Subject: Response to NDEP September 18, 2008 Comments
Data Validation Summary Report (DVSR), Phase B Source Area Investigation
Soil Gas Survey, Tronox LLC Facility, Henderson, Nevada
Dated August 25, 2008

Tronox Response to Comments

September 18, 2008 NDEP Letter Regarding Data Validation Summary Report (DVSR), Phase B Source Area Investigation Soil Gas Survey, Tronox LLC Facility, Henderson, Nevada (August 2008)

PHOTOGRAPHIC LOG

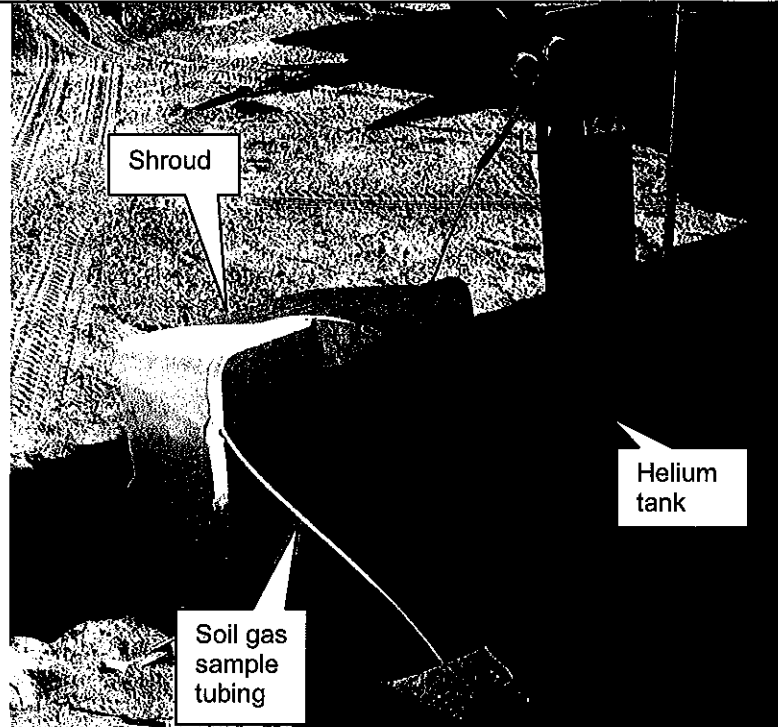
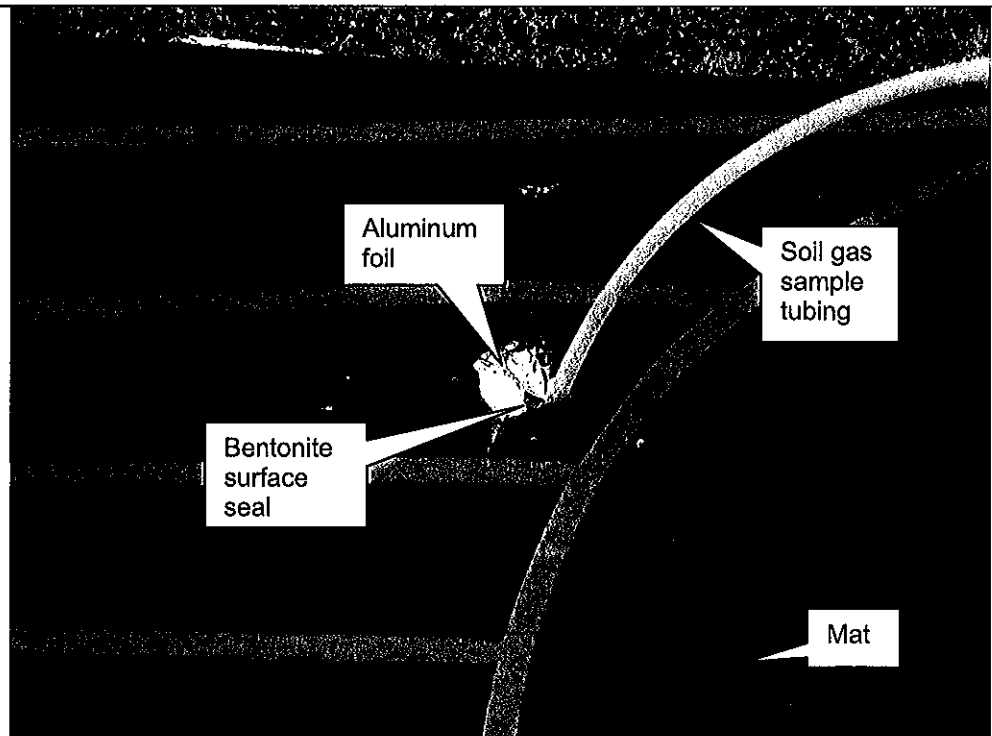
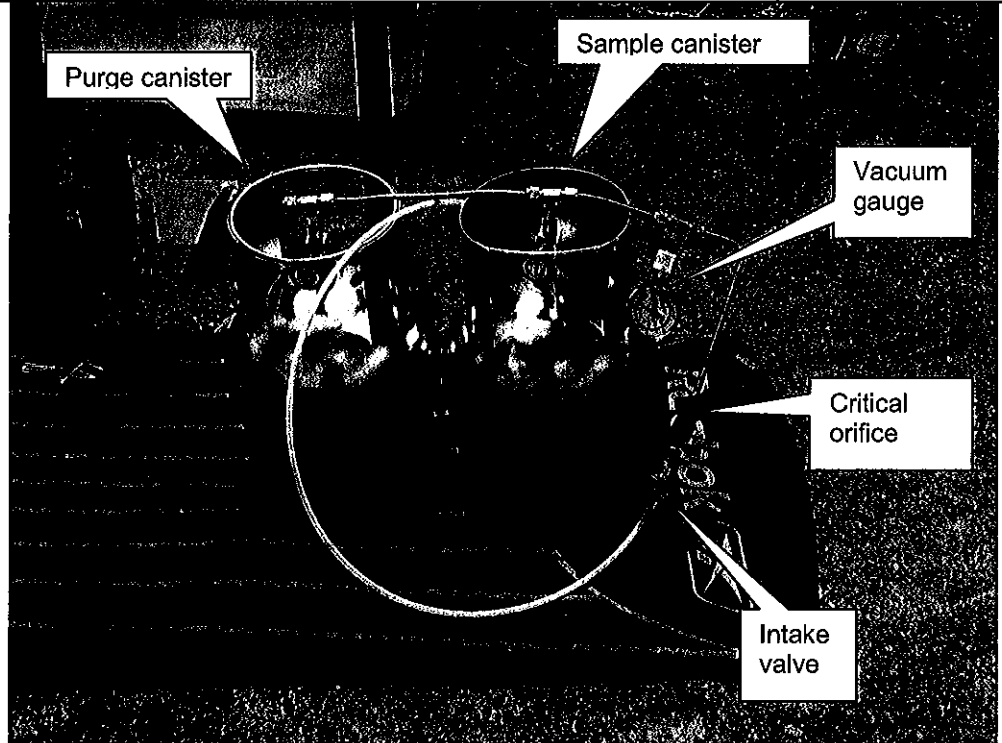
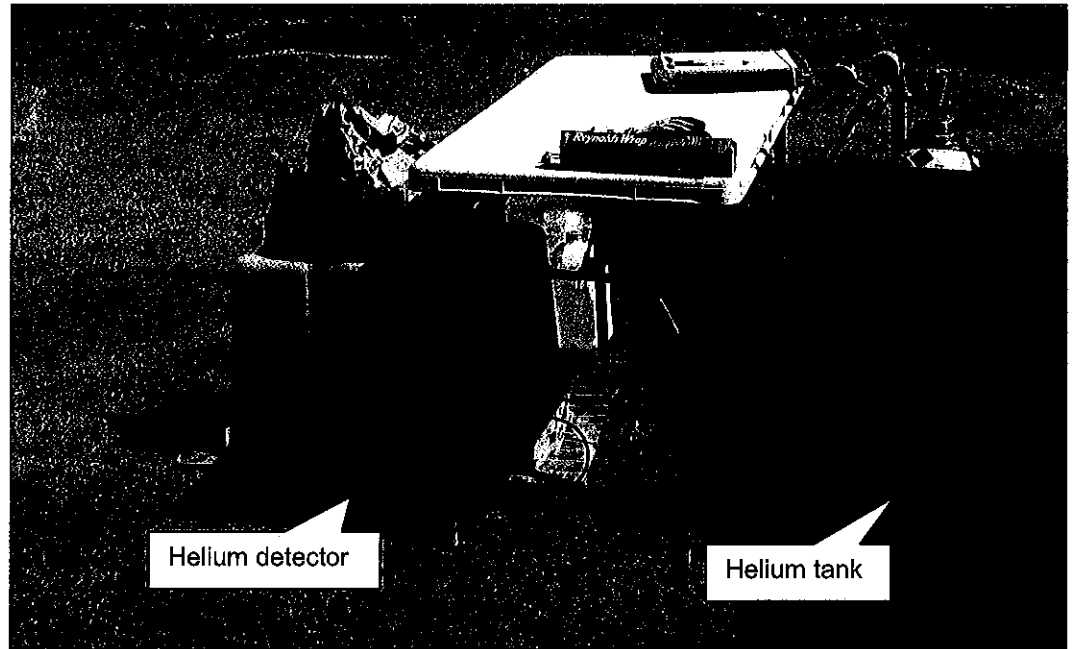
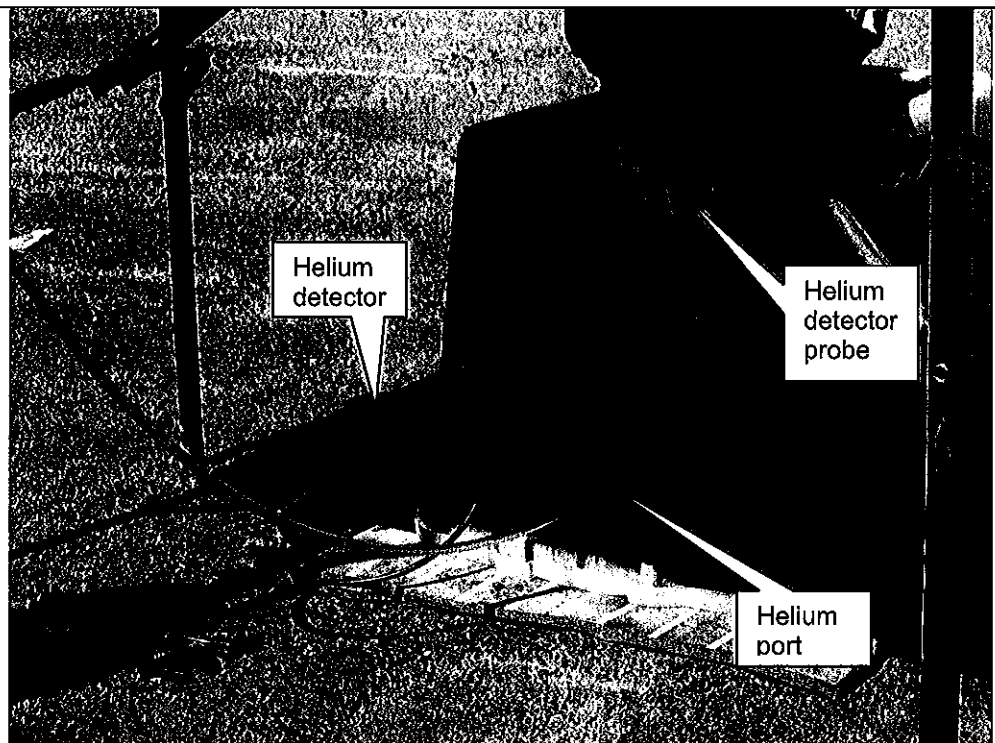
- 1 **Helium Analysis:** Review of the laboratory reports from Columbia Analytical Services shows that helium analysis, using a modified method 3C, was performed on the Summa canister samples. It is unclear why helium analysis was required and why the soil gas samples would be exposed to helium. The DVSR should provide details on why helium analysis was performed along with a discussion of what impact helium detection in a sample has on the TO-15 results. For example, does helium indicate a soil gas sample was influenced from a purge gas? If helium detection in a sample does impact the VOC results the DVSR should also provide a validation of the helium analysis along with a discussion of the impact of helium results on the VOC data.

For the Phase B soil gas survey, the above-ground portion of the sample system (i.e., summa canisters, flow-controller, vacuum gauge, valves and tubing connections) was placed under a shroud (plastic box). Helium gas (provided by a compressed gas vendor) filled the shroud, creating an atmosphere surrounding the sampling system with between 5% to 55% helium. A hand-held helium meter was used to monitor the atmosphere within the shroud to ensure that the helium concentration was maintained as each sample was collected (see the attached **photos numbered 1 through 6**).
